**Subject:** Shoulder Paving Policy

## MEMORANDUM

Date: November 2, 2016  
To: Susanna Chan, PE  
From: Marcy Kamerath, CPSWQ, QSD/QSP, Franz Haidinger, PE  
Subject: Los Altos Shoulder Paving Policy (Standard Detail SU-20, May 2010)

Figure 3 - Recommended revisions to the Policy

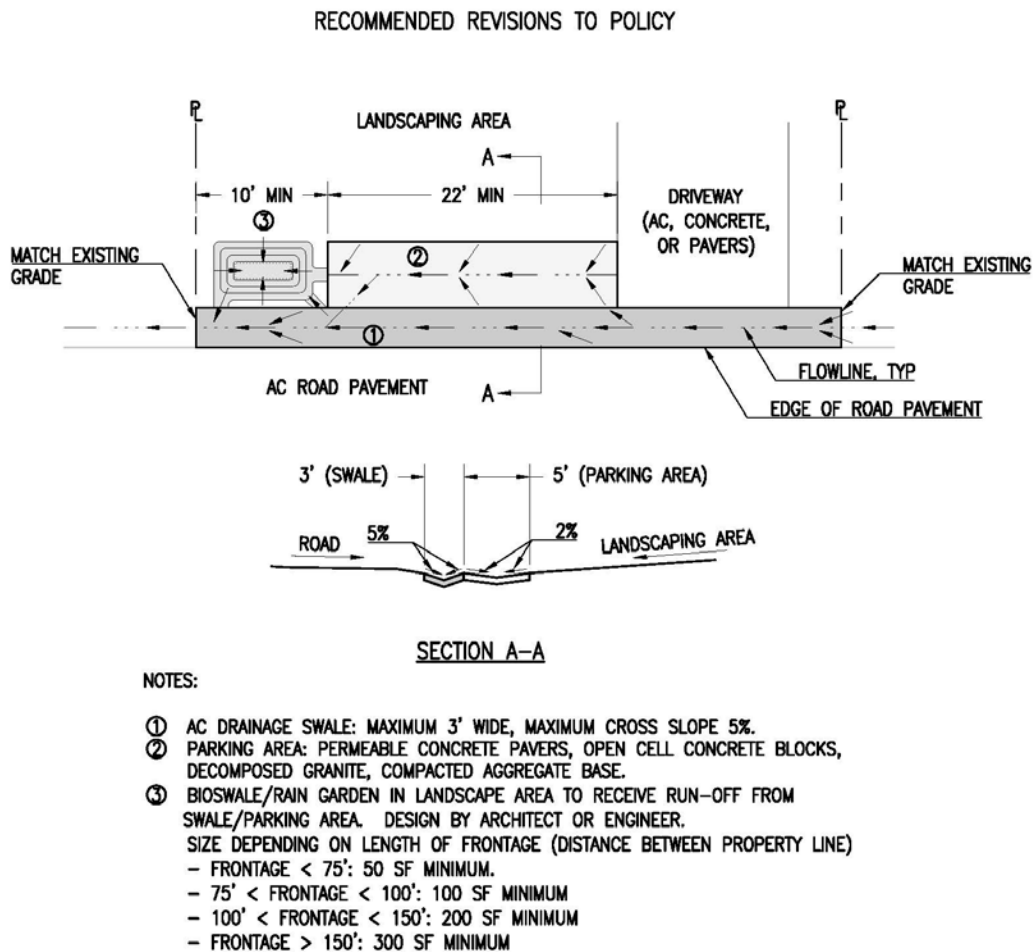
Based on known public concerns with the Policy, site visit observations, consultation with the City and Subcommittee, and NCE's qualitative assessment of alternative pavements, NCE developed three recommended revisions which are illustrated in **Figure 3** and discussed in detail below.

- Flow routing – Flow paths are presented in Figure 3 to provide clarification and guide contractors implementing the shoulder improvements. Constructing improvements consistent with the illustrated flow paths will promote positive drainage through the swale, allow the shoulder parking area to receive and capture some runoff, and route excess flows to the drainage swale.

- Specify slopes for drainage swale and shoulder parking area – A typical cross section specifies a 5% slope for the drainage swale to promote positive drainage away from the roadway. A 2% slope is specified for the parking area to promote positive drainage to landscaped areas where they are installed downgradient from the parking area, and/or to convey excess flows which do not infiltrate into the shoulder parking area into the drainage swale.

- Match existing grades – To reduce drainage issues associated with planned improvements, the Policy should specify that the up and downstream limit of improvements must match existing grade.

Three clarifications should be made regarding the AC drainage swale. First, the policy should emphasize and clarify that the maximum width of the AC drainage swale to be installed is limited to 3-feet. The length of the AC drainage swale will be dictated by the length of the frontage of a given property. Second, the AC drainage swale should be installed with cross slopes that are a maximum of 5% to promote positive drainage, while considering accessibility recommendations. Finally, the AC swale should be installed so that stormwater flows are conveyed to the permeable parking area and Green Infrastructure (GI) features (e.g. bioswale or rain garden), and excess runoff is conveyed from these features back to the AC drainage swale.

Figure 5 - Various patterns for installation of permeable concrete pavers (Interlocking Concrete Pavement Institute, 2004)

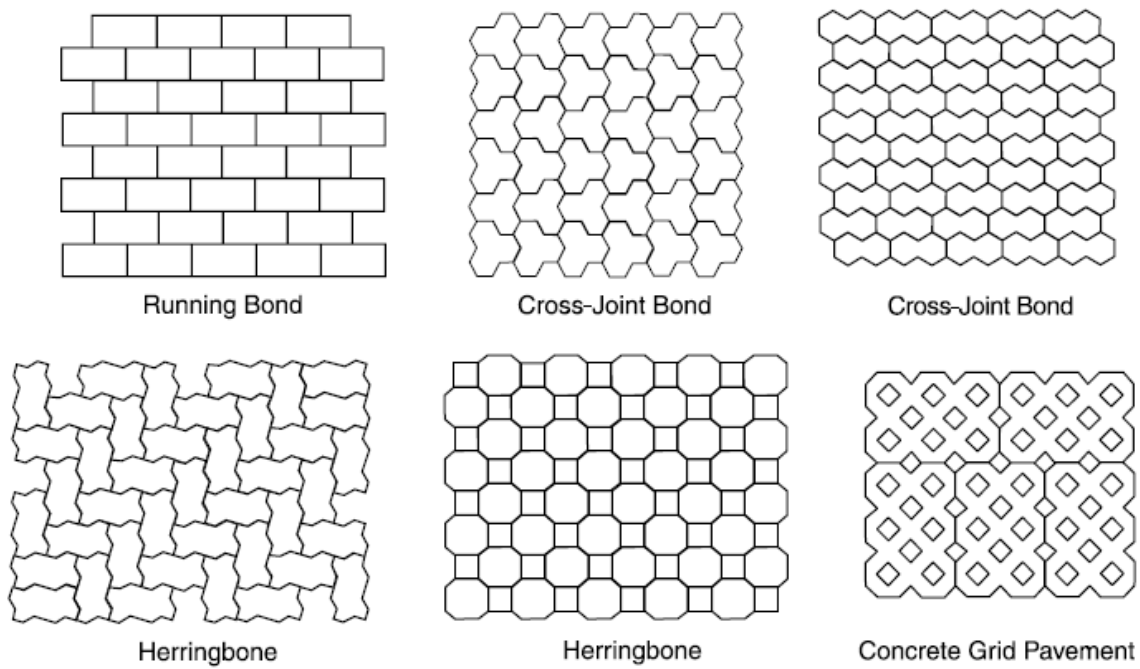
**Rationale:** The Policy appears to be misinterpreted in some locations and the installation of AC in the parking area has a significant street-widening effect (e.g., Figure 1). Permeable materials can help to capture and treat a portion of stormwater runoff, and are more consistent with the desired aesthetic. Based on a qualitative review, pervious concrete pavers, open cell concrete blocks, compacted aggregate base, and stabilized decomposed granite are recommended for use in the parking area. While several alternatives exist, these materials are recommended because they are consistent with the desired rural aesthetic. In addition, these recommended materials are consistent with the City of Los Altos' Residential Design Guidelines, which suggest that residents consider paving materials other than plain concrete or asphalt. For driveways, the guidelines suggest the use of brick pavers, stone, gravel, interlocking pavers, and exposed aggregate, and special concrete for to provide visual interest<sup>8</sup>. These permeable materials provide some stormwater benefits, and are available in multiple color, texture, and patterns which the City can further specify to meet a desired aesthetic (**Figures 4 and 5**).

- Use of AC, porous AC and pervious concrete should be prohibited for use in the parking area to address aesthetic concerns
- Installation of permeable concrete pavers will require excavation into the subgrade to create storage for stormwater runoff and to match existing grades at the property line
